# Kerry Central Recycling Facility Ltd

## Response to Further Information Request Folder 1

**Re: Planning Application by Kerry Central Recycling Facility Ltd. (Planning Ref. No. 2415/08) - Response to Further Information Request**

**Figure 2.1**

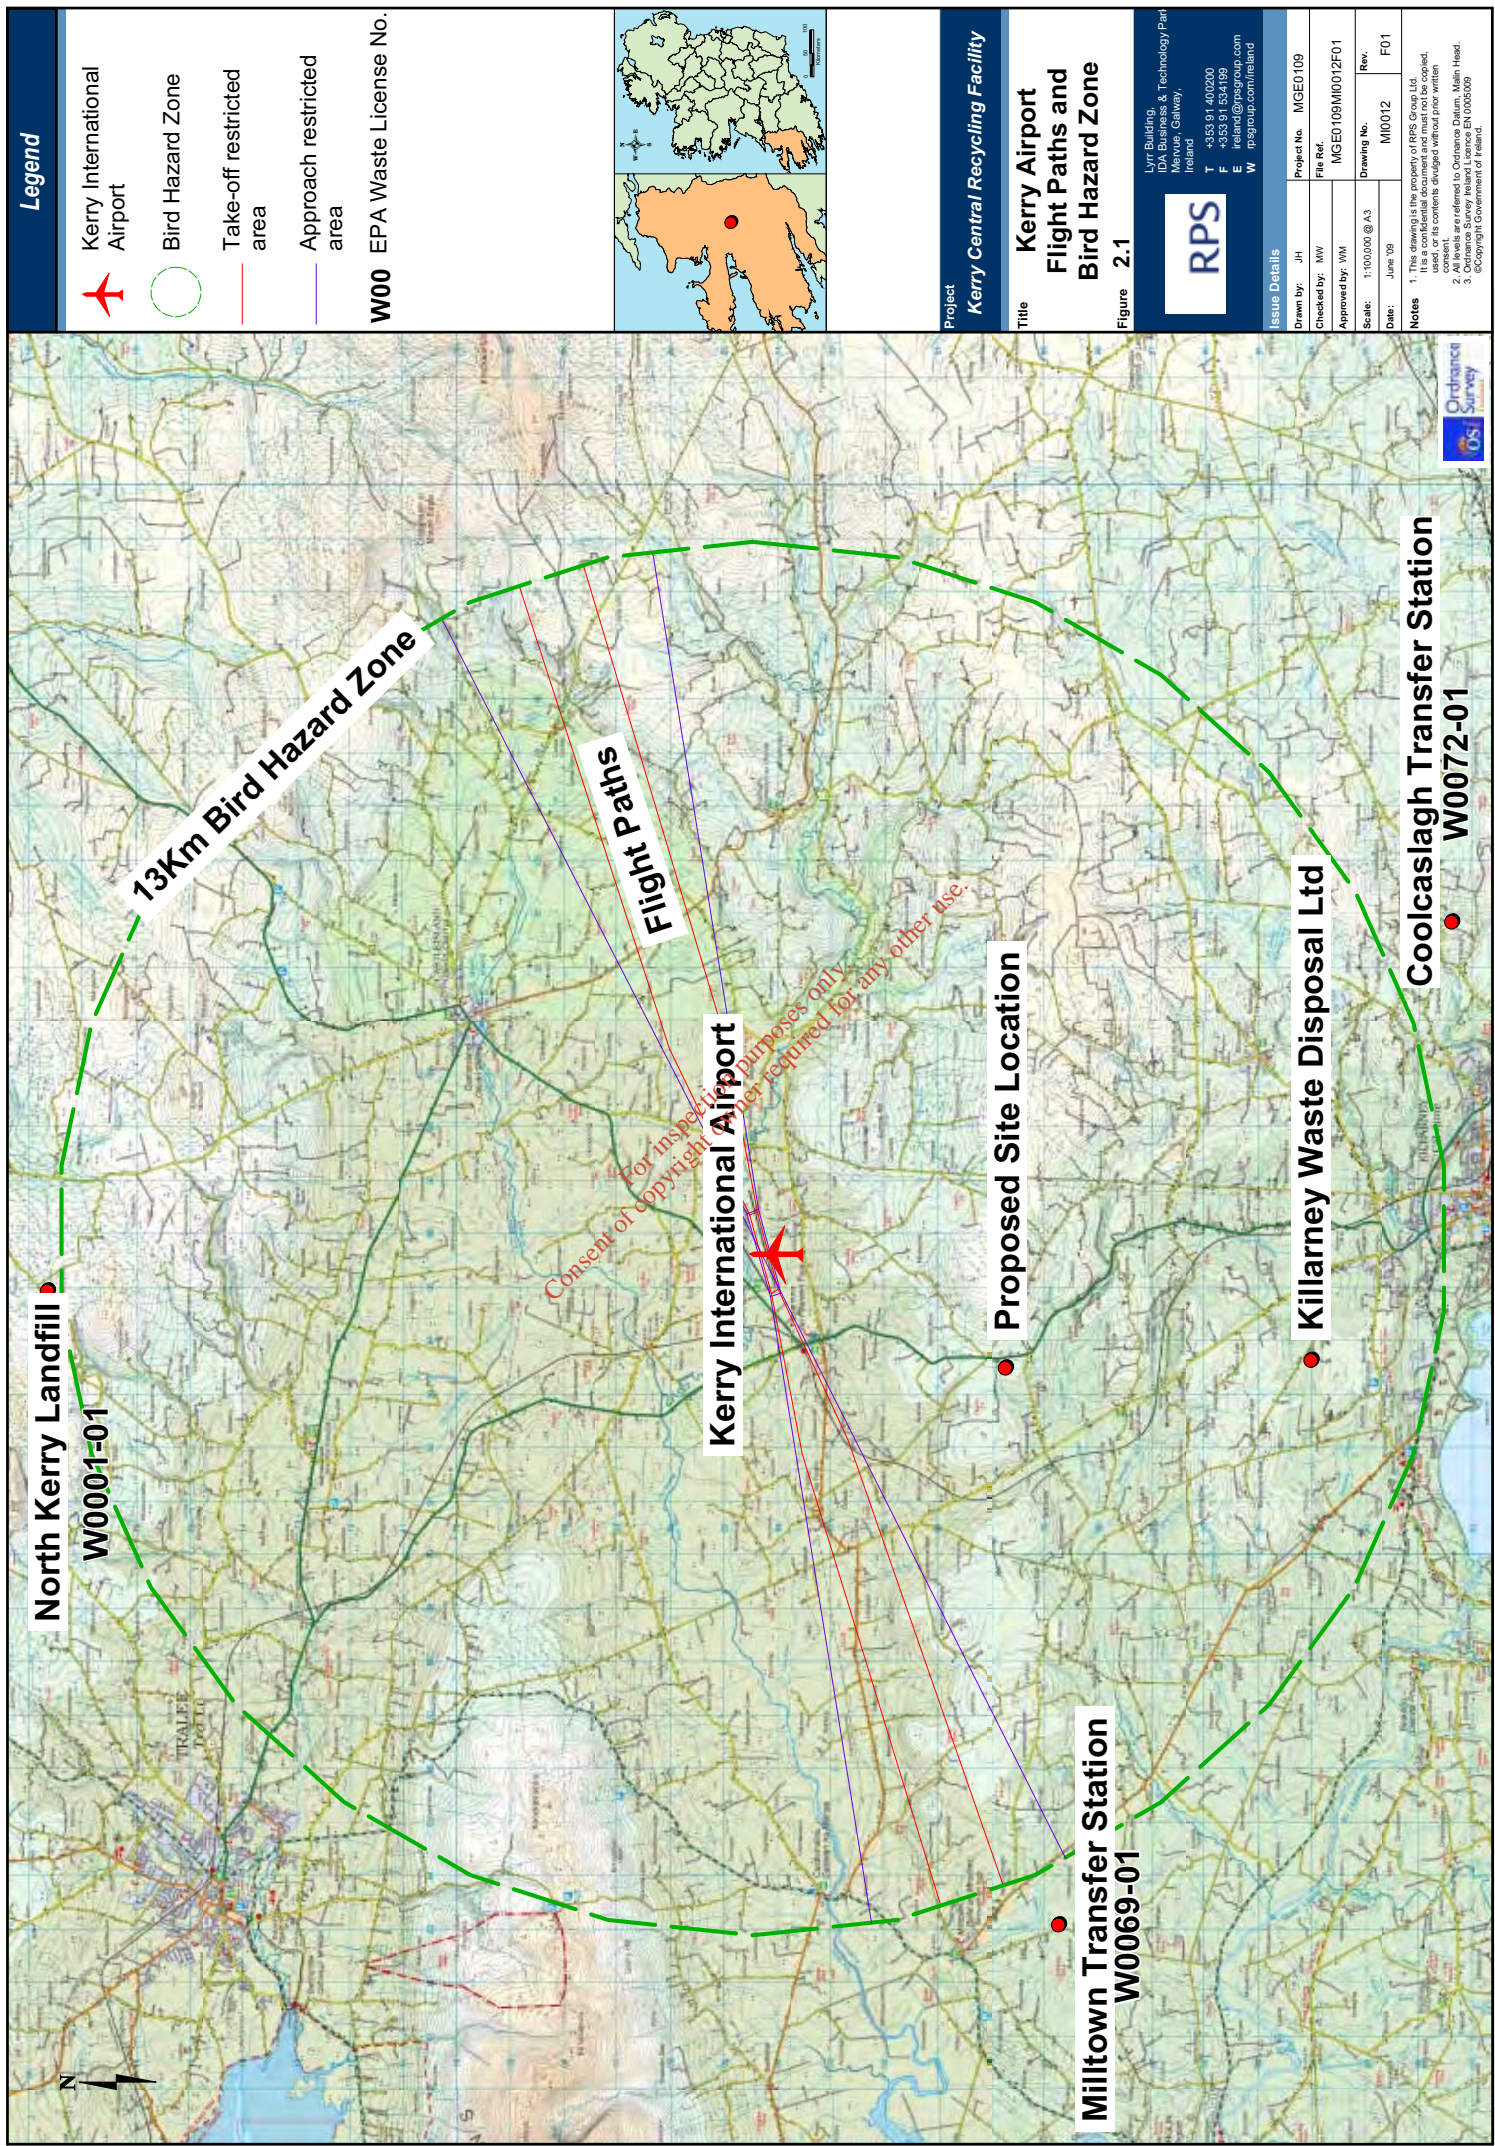
***The Planning Authority considers that the effect of the proposed facility on Kerry Airport has not been adequately addressed. In particular, the potential of the facility to attract birds has not been considered. What mitigation measures are proposed, needs to be clarified.***

Mr. Peter Moore, Manager of Kerry Airport, issued a map to RPS which is reproduced in **Figure 2.1** overleaf. This map indicates a 13km zone called the "*Bird Hazard Zone*" around the airport. This zone relates to the air space where aircraft coming in to land and taking off would have the highest possibility of collision with birds. This zone has most significance along the flight paths (i.e. take off and landing approaches to the airport) also identified on **Figure 2.1**. The proposed facility will not be located on or in the vicinity of these flight paths. Therefore it is considered that the proposed facility will have no impact on the operations of Kerry Airport.
